**RE: LU-22-61 – Response to TAC Comments  
77 Meredith Way – Randi & Jeff Collins – Tax Map 162 Lot 16  
TFM Project #47442-00**

- **Updated Drainage Summary**
- **Site Development Plan set entitled “Proposed 2 Lot Subdivision Plan, 77 Meredith Way, Portsmouth, New Hampshire”, prepared by TFMoran, Inc., dated July 1, 2022, last revised October 6, 2022 (1 copy at 22”x34).**

TAX MAP 162 LOT 16  
**SUBDIVISION PLAN**  
**2 LOT SUBDIVISION**  
**77 MEREDITH WAY**  
**PORTSMOUTH, NEW HAMPSHIRE**  
**COUNTY OF ROCKINGHAM**  
OWNED BY  
**RANDI & JEFF COLLINS**

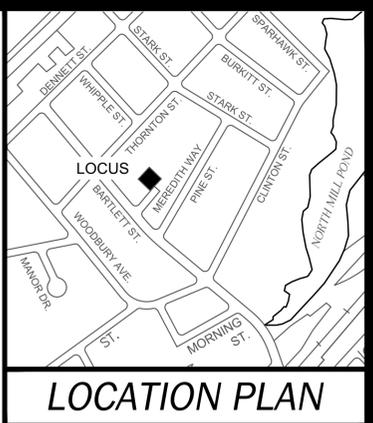
2. A note will be added to sheet C-07 detailing easement turnaround area will be constructed with Heavy Duty Pavement.

***Revised Note 10 on Sheet C-07, also added Note 8 to Sheet C-03, Note 15 to Sheet S-02 & Note 14 to Sheet S-03.***

1. Sheet S-02 Subdivision Plan:
  - a. Added Turnaround Easement and Note 15.
  - b. Added Sewer Easement and Note 14
  - c. Added Plan Reference 4 (S-03 Easement Plan).

**TAX MAP 162 LOT 16  
EASEMENT PLAN  
2 LOT SUBDIVISION  
77 MEREDITH WAY  
PORTSMOUTH, NEW HAMPSHIRE  
COUNTY OF ROCKINGHAM**

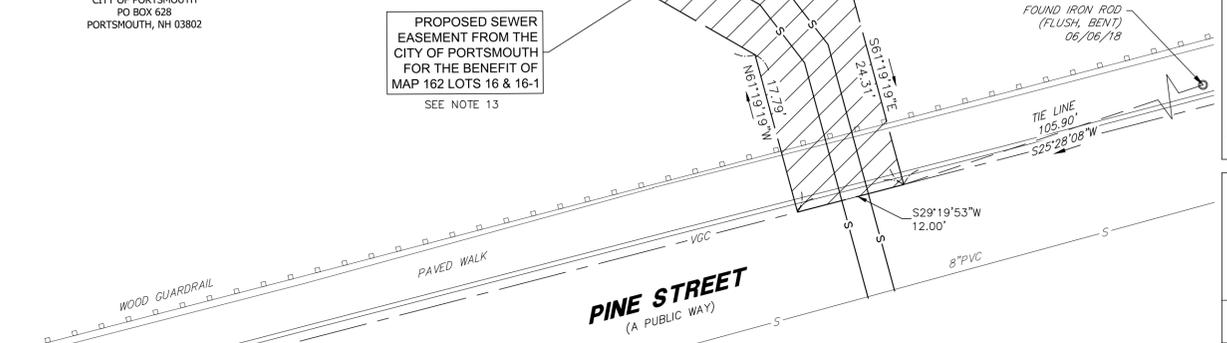
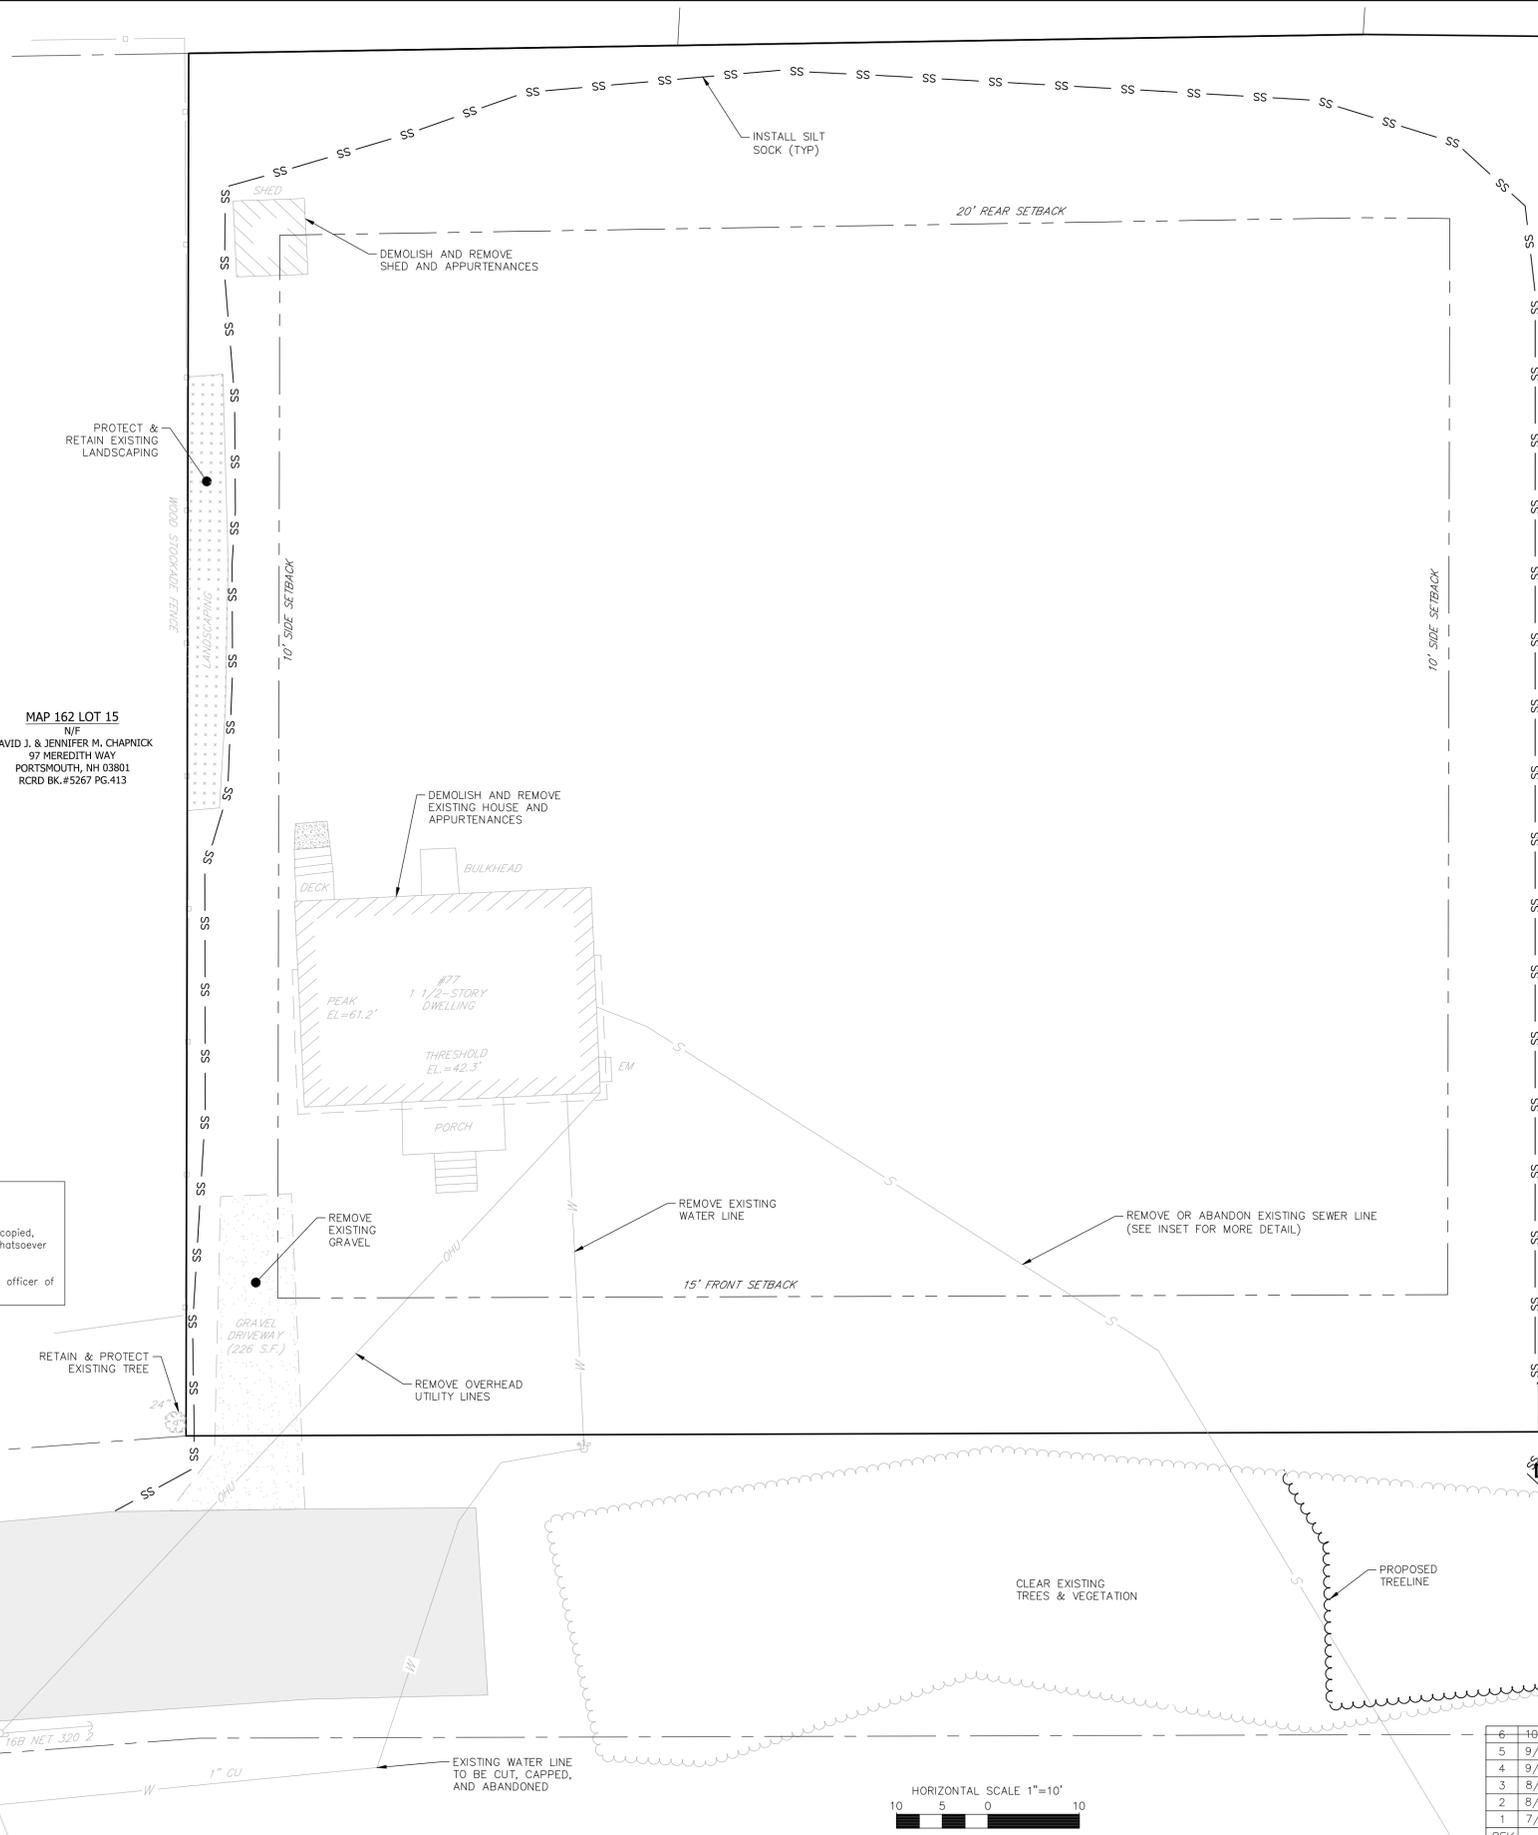
3. Applicant will add an Easement Plan to the plan set (indicated as S3).

***An Easement Plan has been added to the plan set, see Sheet S-03.***

TAX MAP 162 LOT 16  
**SITE LAYOUT PLAN**  
**PROPOSED 2 LOT SUBDIVISION**  
**77 MEREDITH WAY**  
OWNED BY  
**RANDI & JEFF COLLINS**  
PREPARED FOR  
**RANDI & JEFF COLLINS**  
**1"=20' (11'X17')**  
**SCALE: 1"=10' (22'X34')** **JULY 1, 2022**

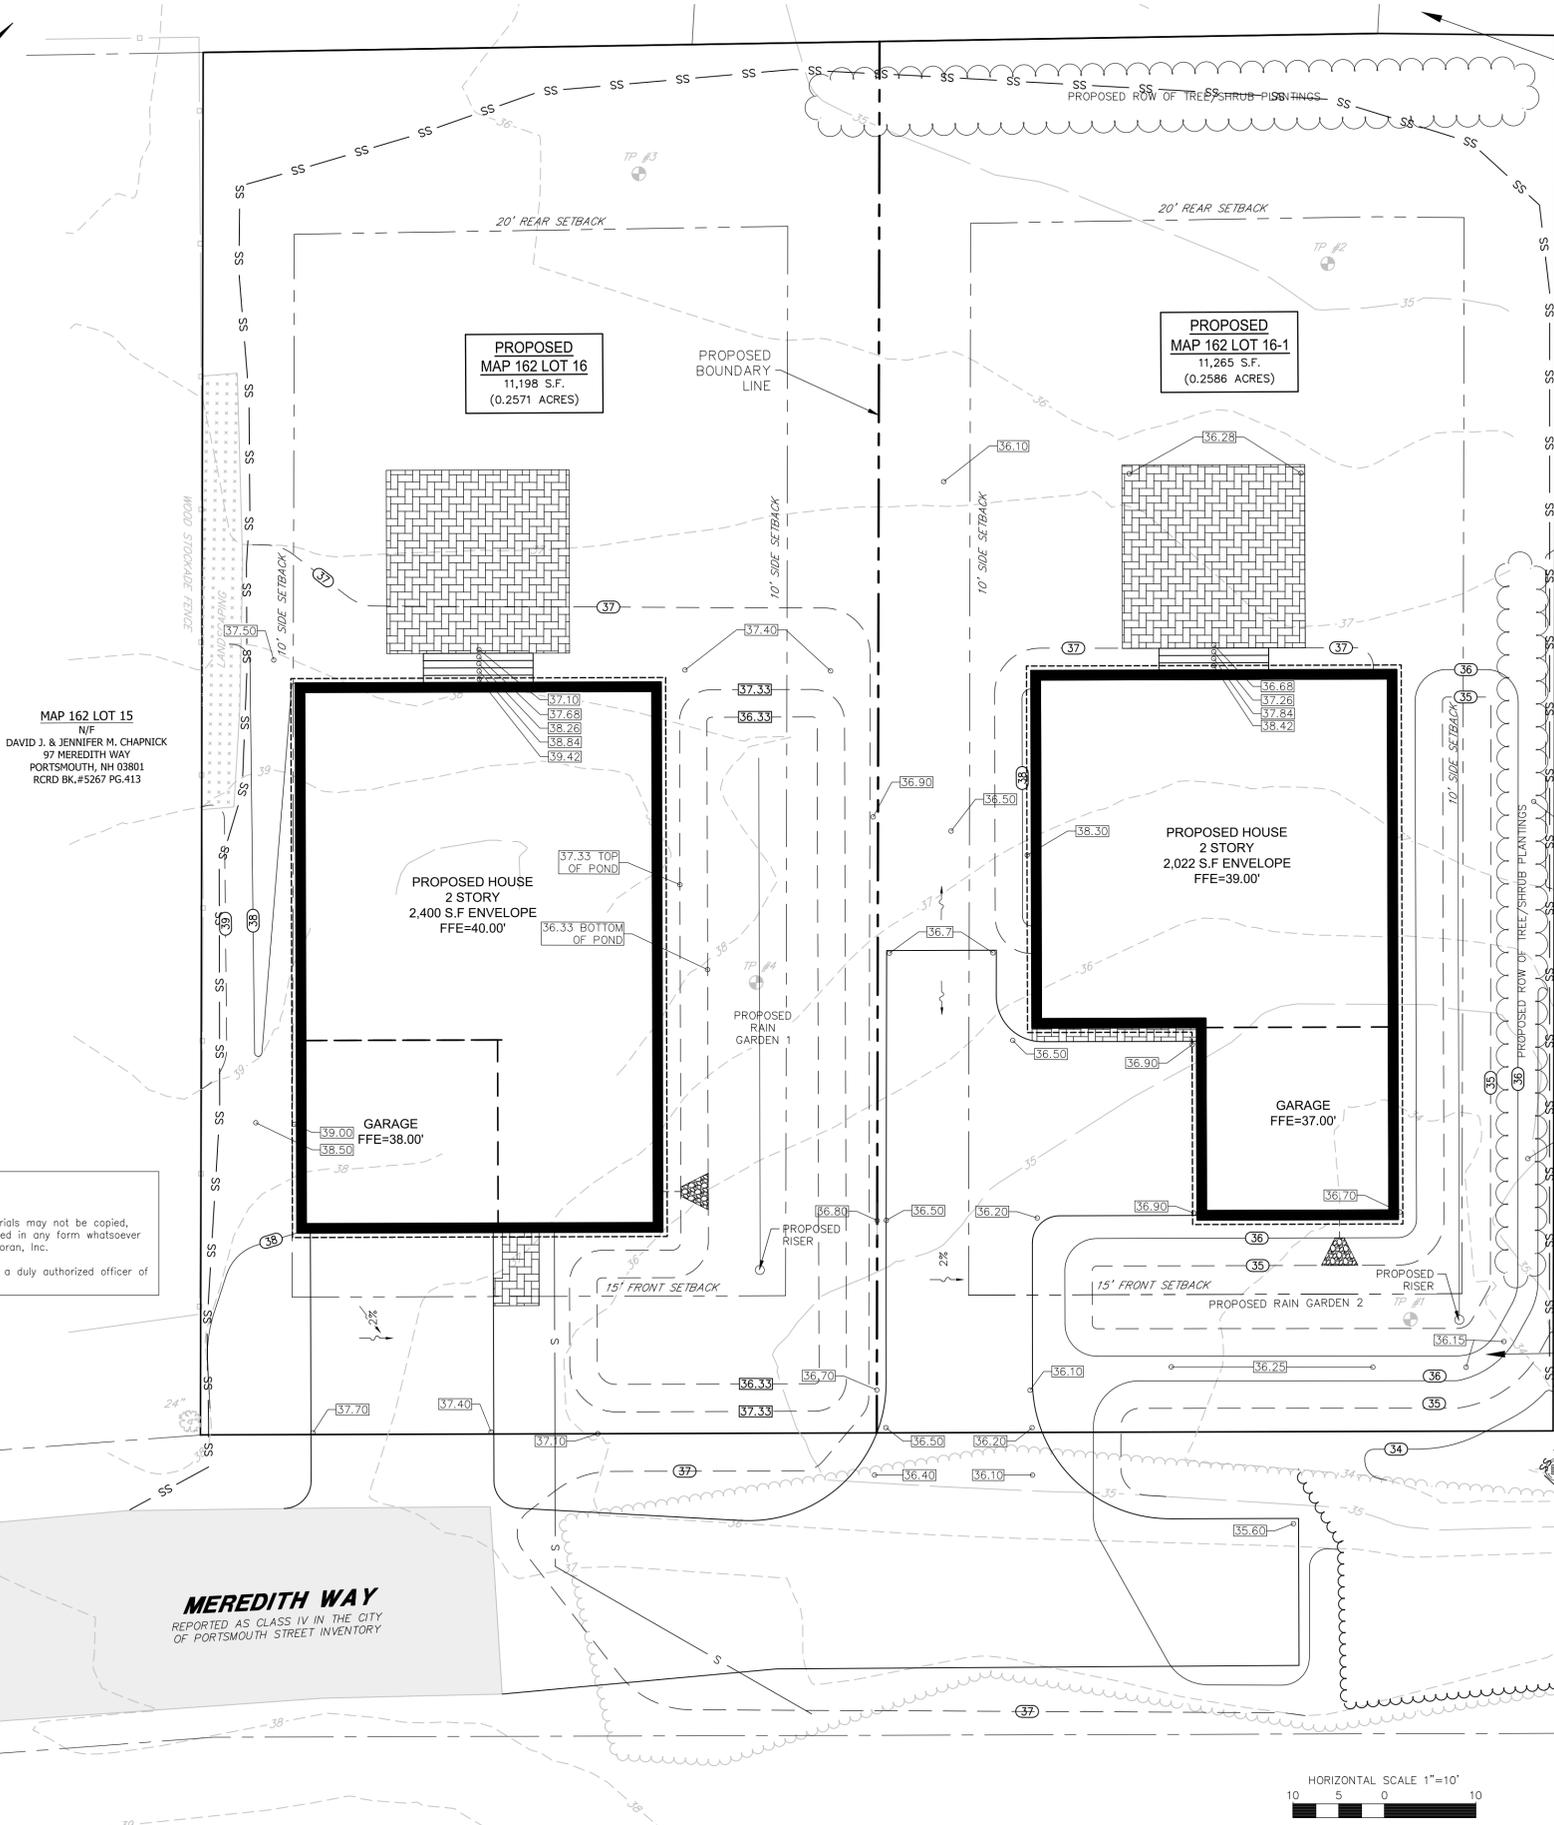
5. A note to sheet C-03 will be added to the plans stating that the proposed principal structures will be located in substantial compliance with siting depicted in the plan set.

***Added Note 9 to Sheet C-03.***

TAX MAP 162 LOT 16  
**GRADING & DRAINAGE PLAN**  
**PROPOSED 2 LOT SUBDIVISION**  
**77 MEREDITH WAY**

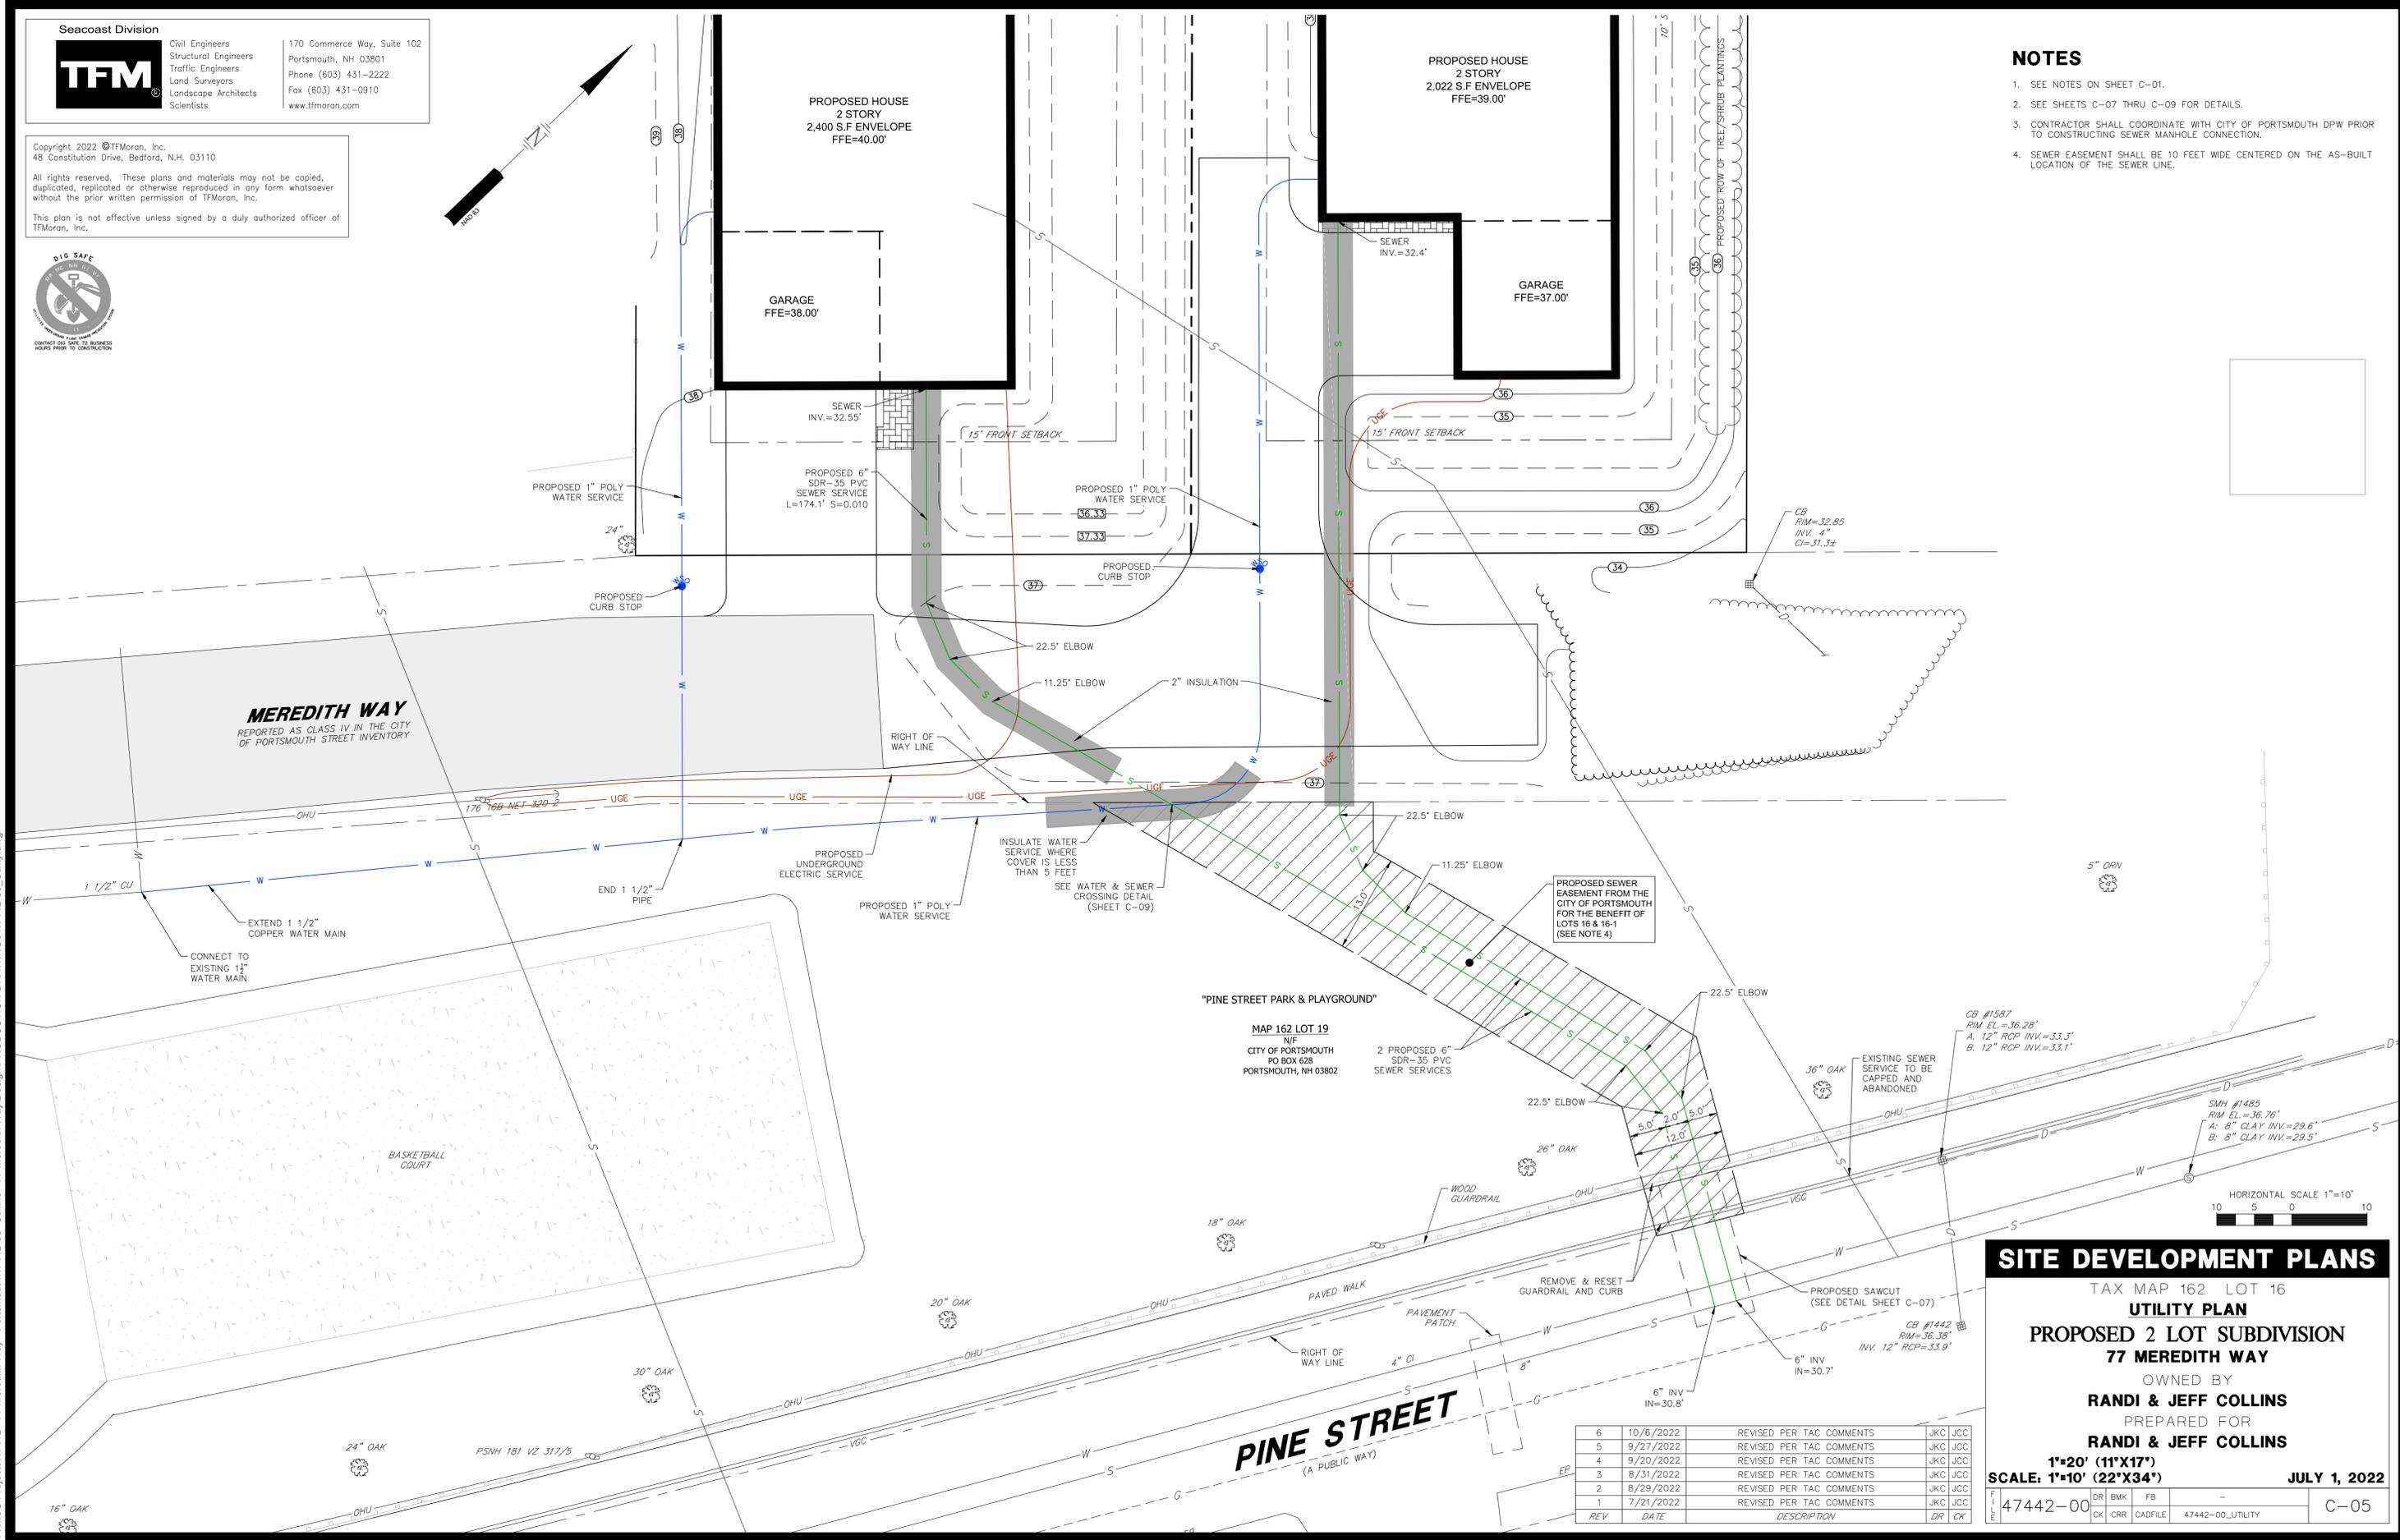
1. POI-3 of Sheet C-04 will be corrected and amended to DPW satisfaction.

7. All runoff from the structures is to be directed towards the appropriate rain gardens.

***After discussing this with DPW, it was determined that the pipe from POI-2 was the pipe that needed to be removed. The pipe from POI-2 has been removed. Updated calculations are included.***

***Revised Note 10 on Sheet C-04.***
